ADDENDUM NO. 2
CONTRACT NO. CP8126-1 – GENERAL, MECHANICAL AND
ELECTRICAL CONSTRUCTION
 DATED: SEPTEMBER 27, 2010

SUFFOLK COUNTY DEPARTMENT OF PUBLIC WORKS
DIVISION OF SANITATION
HAUPPAUGE INDUSTRIAL PARK
S.C.S.D. NO. 18 – INDUSTRIAL SEWER DISTRICT EXPANSION
SUFF 0503

SUFF 0503
ADDENDUM #2 - ITEM Q
SHEET MCW2 - SKETCH # 7

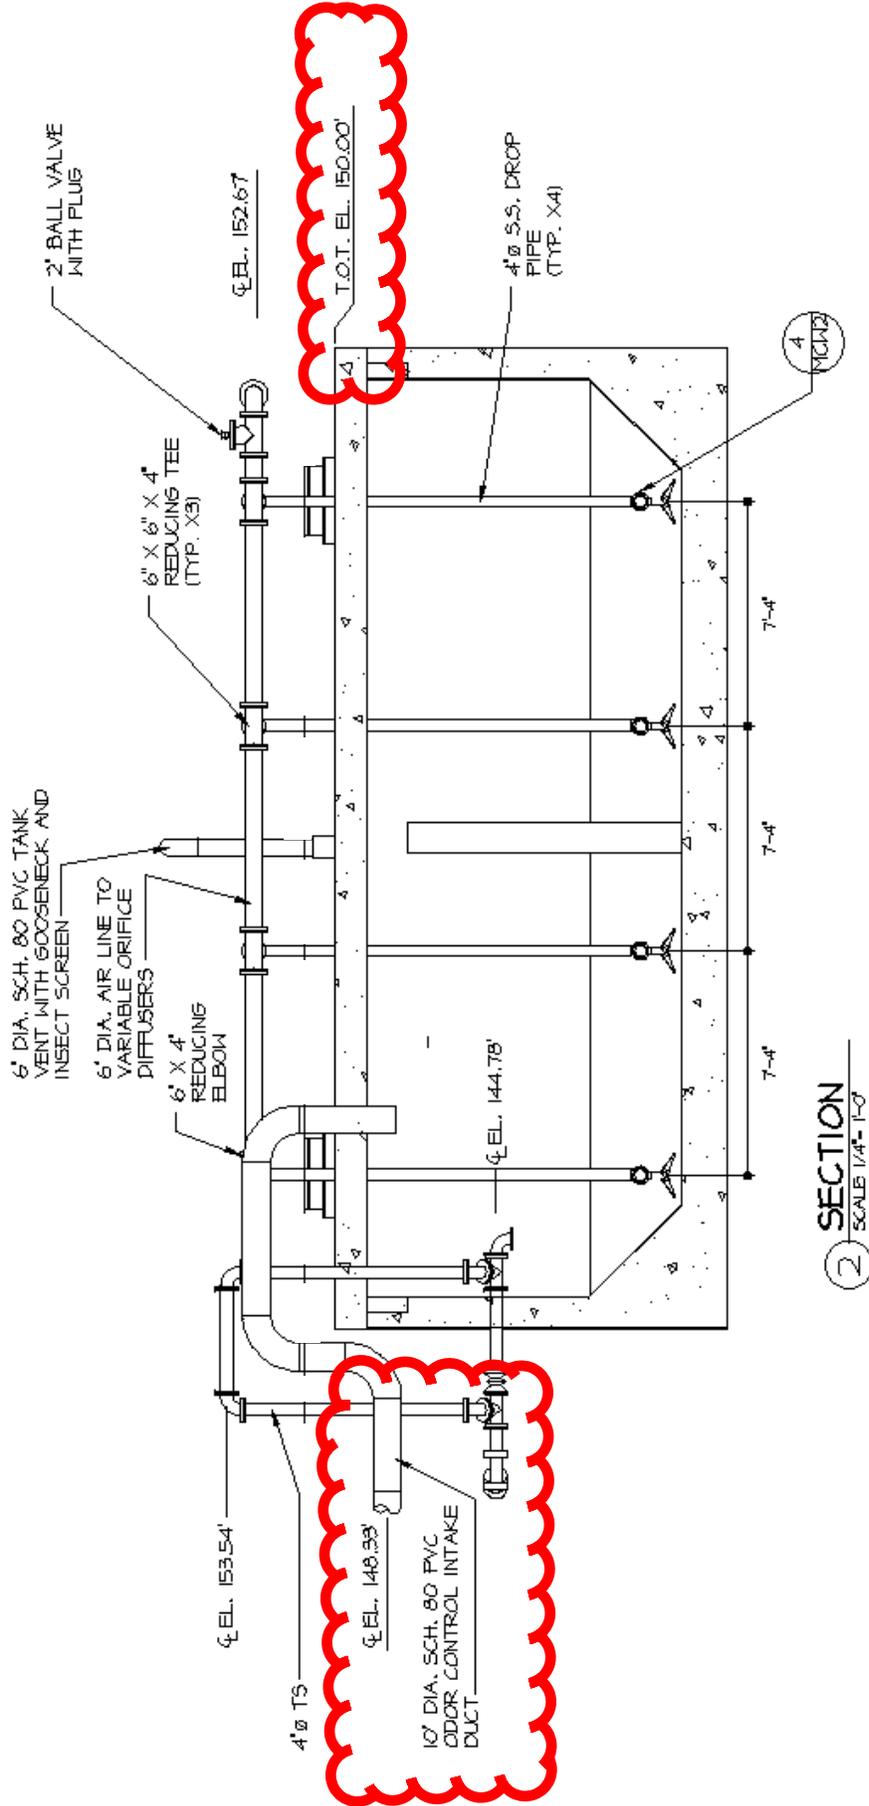
1. Sections #1, #2 and #3: Lower elevation of proposed thickened sludge holding tank and piping by 1 foot so that the T.O.T. elevation is equal to 150.00’. Adjust elevations of proposed piping accordingly. (see sketches #7-9 included herein)

SUFF 0503
ADDENDUM #2 - ITEM R
SHEET MHB1 - SKETCH # 10

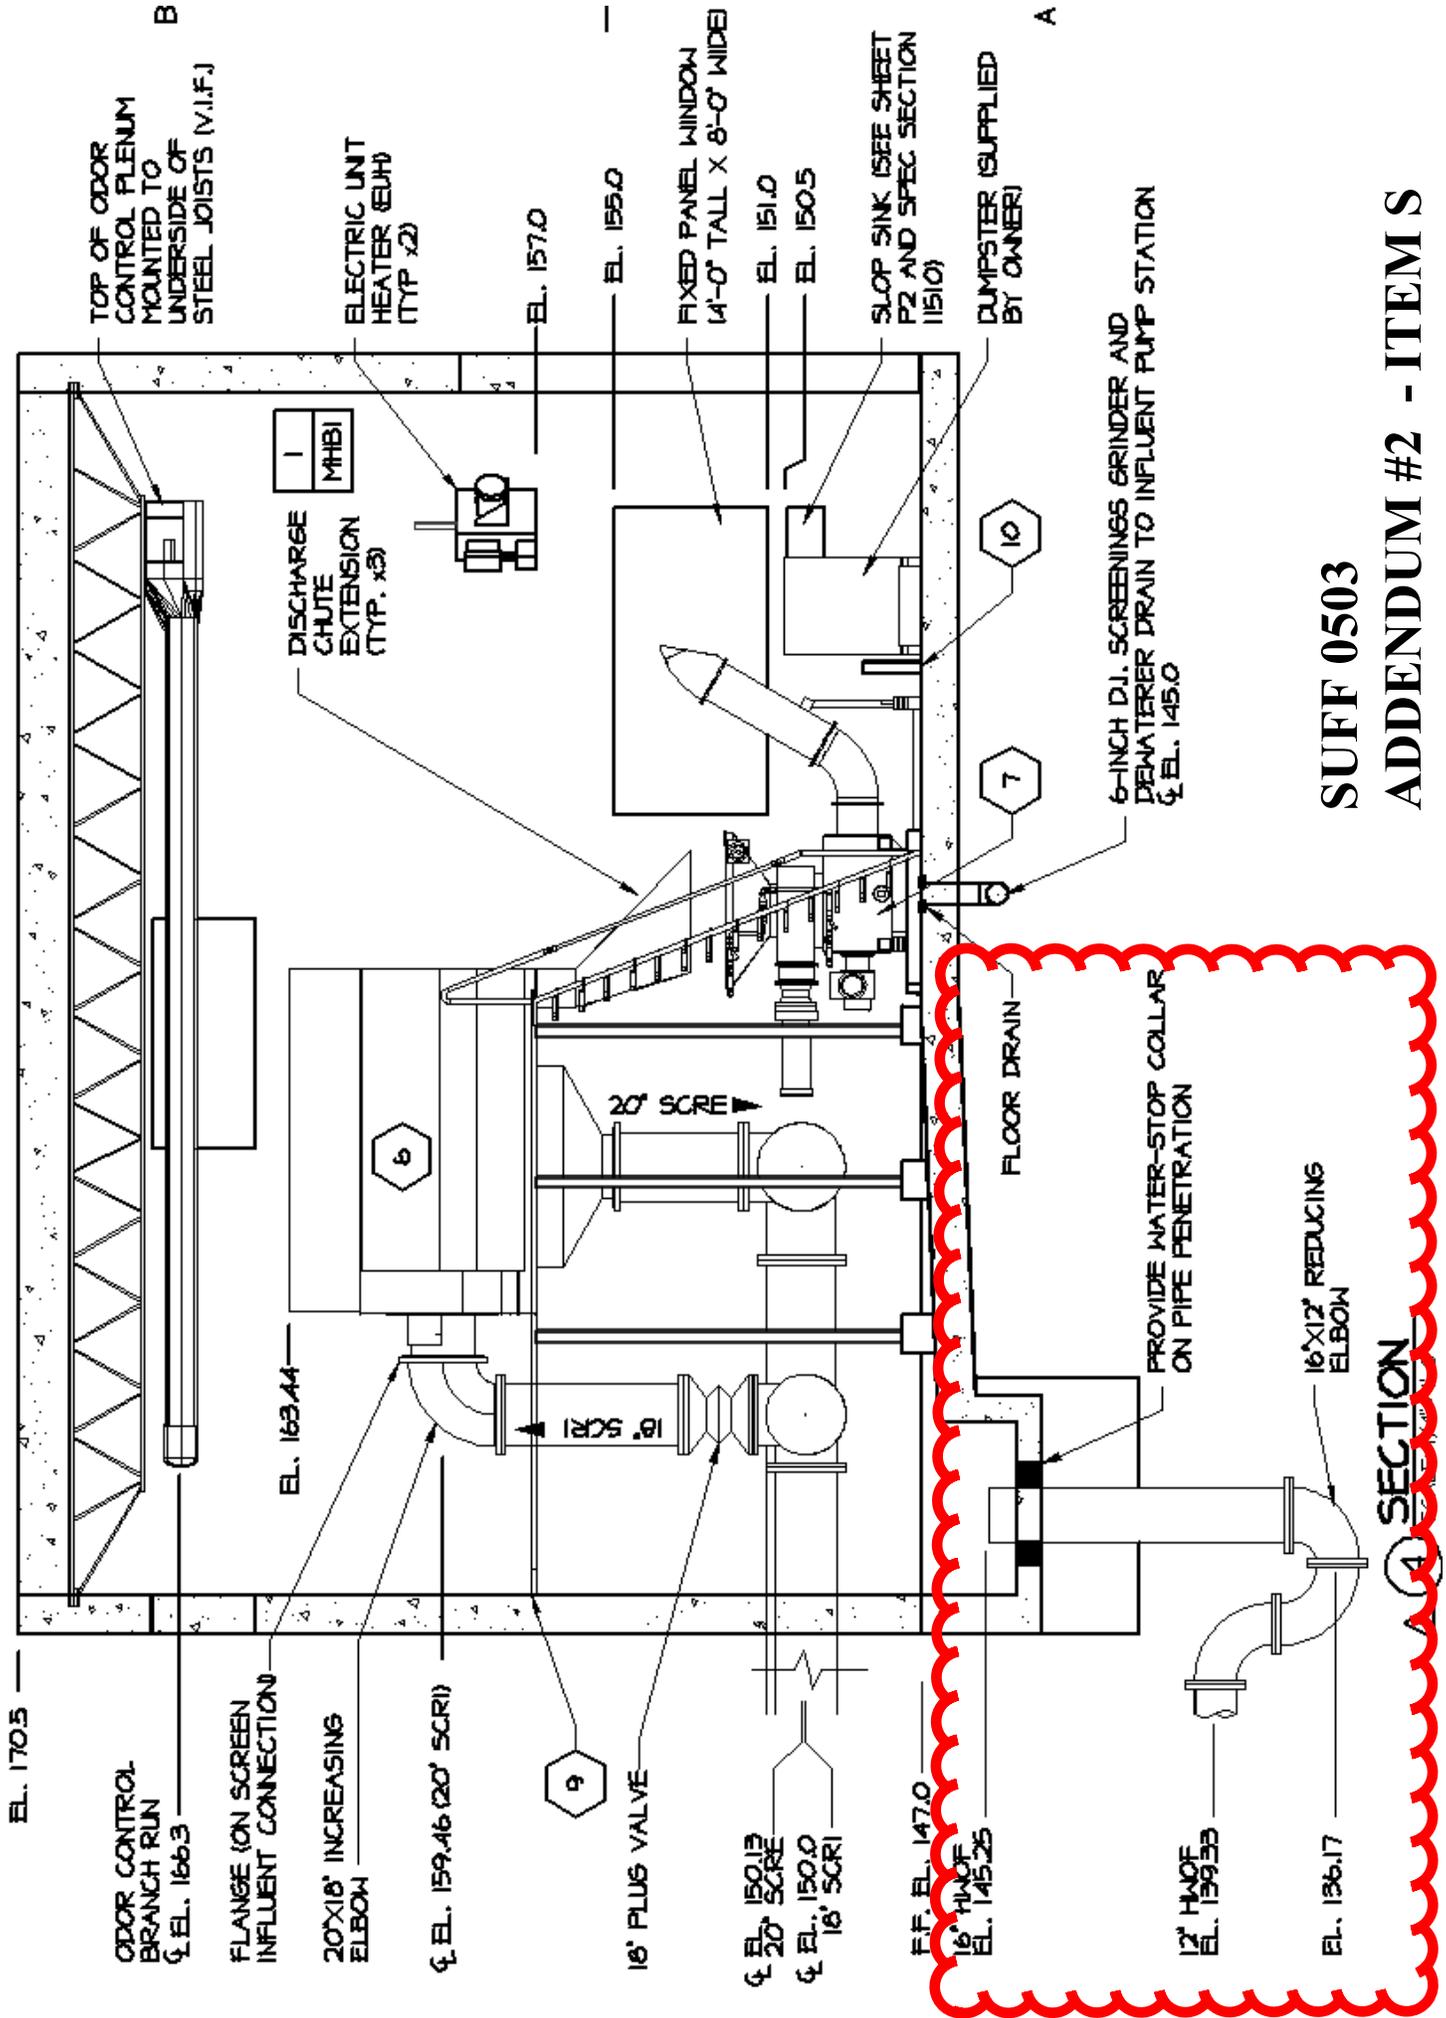
1. Modify callout for rubber parking car stops to read: “4 ft. rubber parking curbs as manufactured by GNR Technologies or equal (TYP. x 9)”
2. Adjust depiction of platform grating within headworks room such that the piping below is visible.
3. Above revisions as shown in sketch #10 included herein.

SHEET MHB2 - SKETCH # 10A

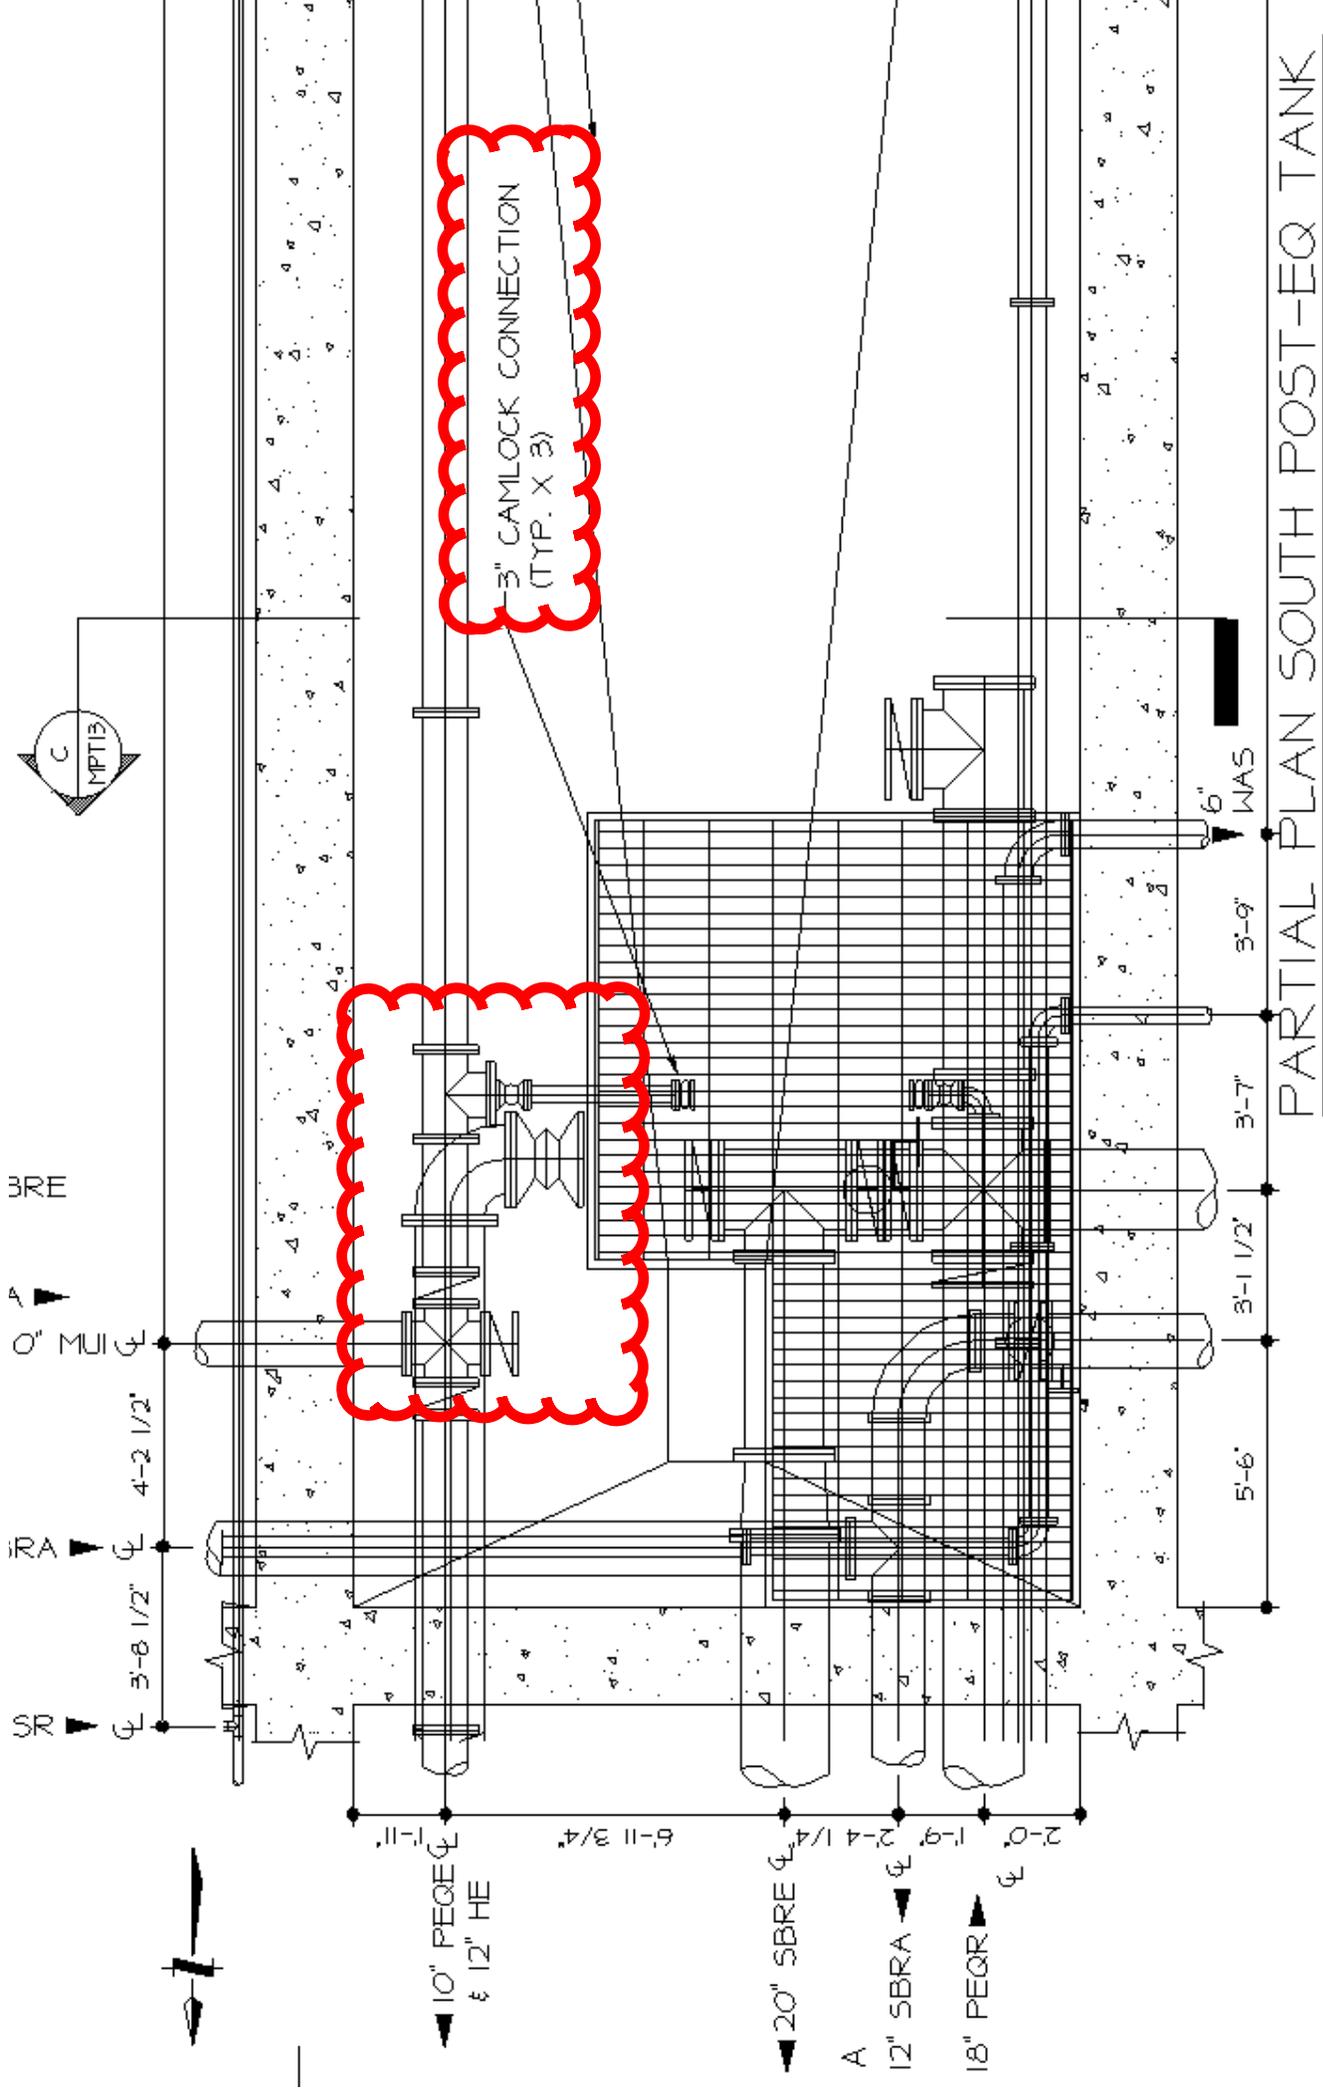
1. Detail #4: Modify to show routing of HWOFF piping leaving the building. (see sketch #10A included herein)

SUFF 0503
ADDENDUM #2 - ITEM T
SHEET MPT7 - SKETCH # 11

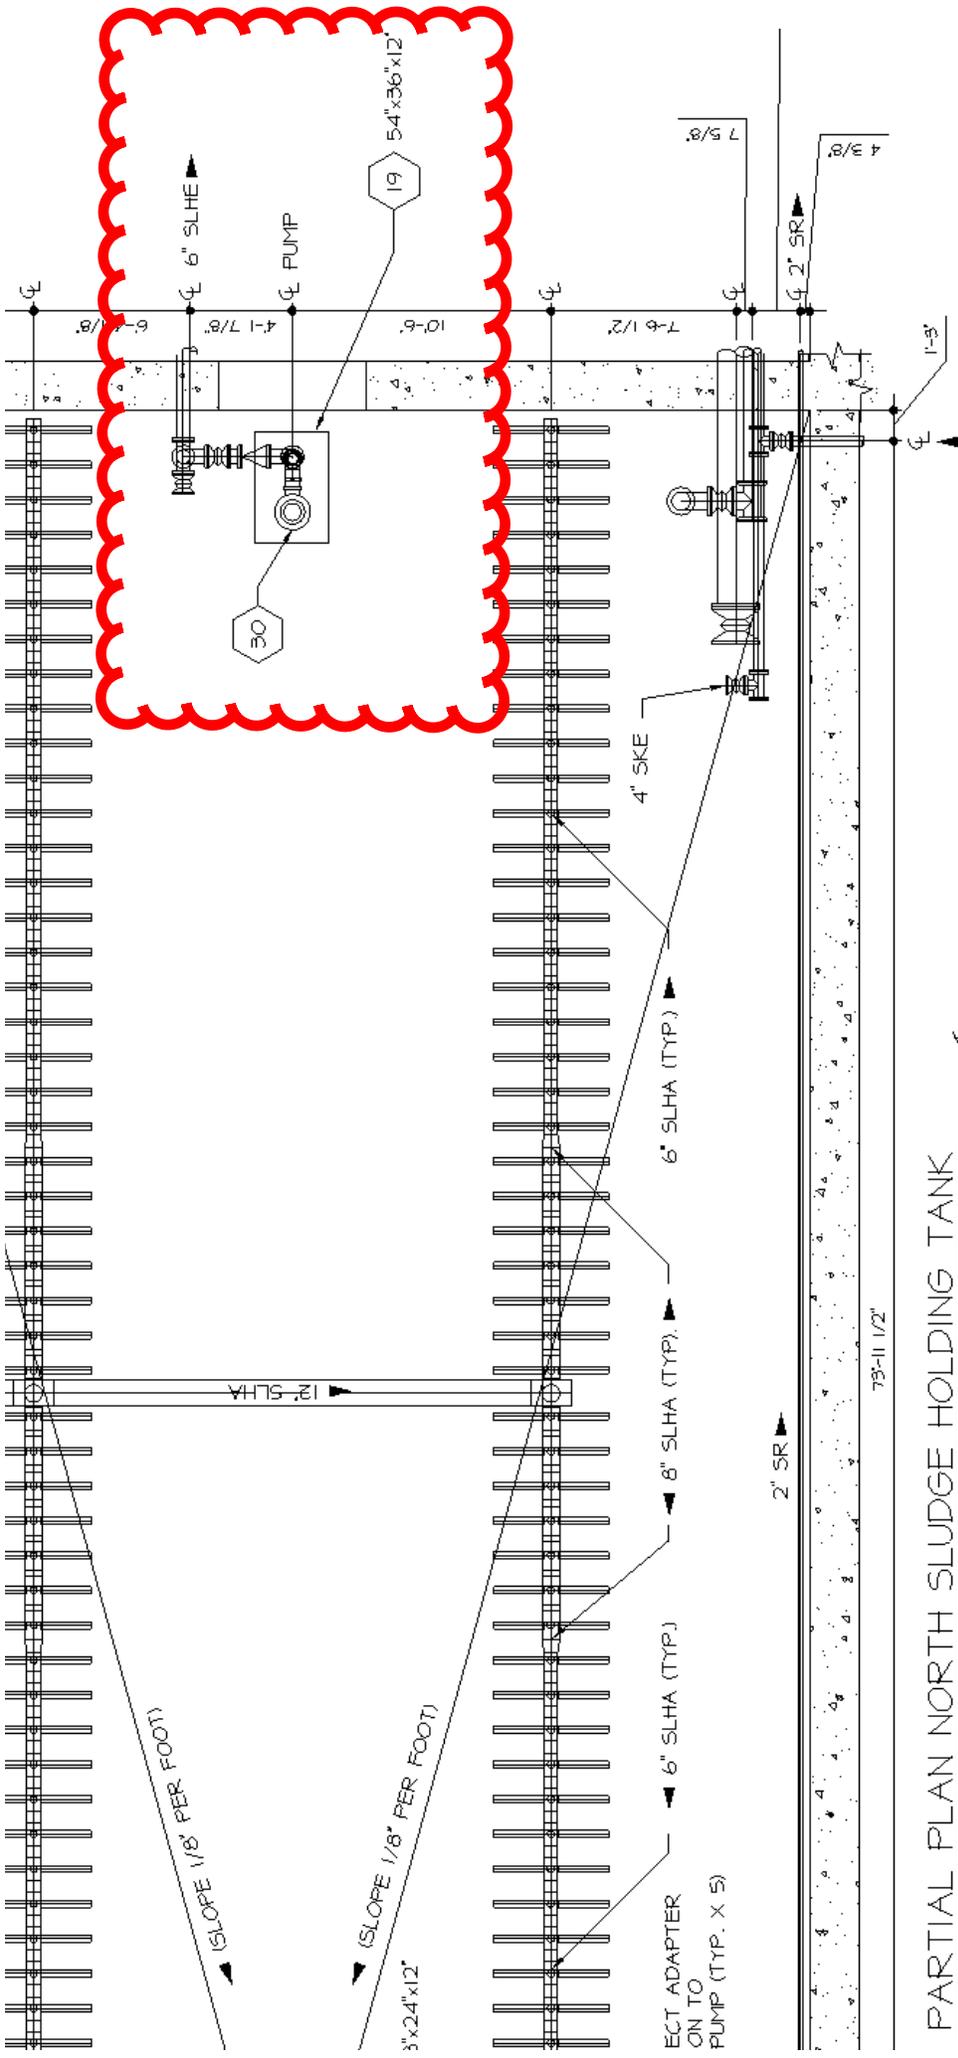
1. PARTIAL PLAN SOUTH POST-EQ TANK:
 - a. Remove the plug valve callout located at south end of tank.
 - b. Add a 90-degree elbow to end of 12” HE line. (see sketch #11 included herein)
 - c. Modify the callout of camlock connection to read “3” Camlock Connection (TYP. x 3)”. (see sketch #11 included herein)
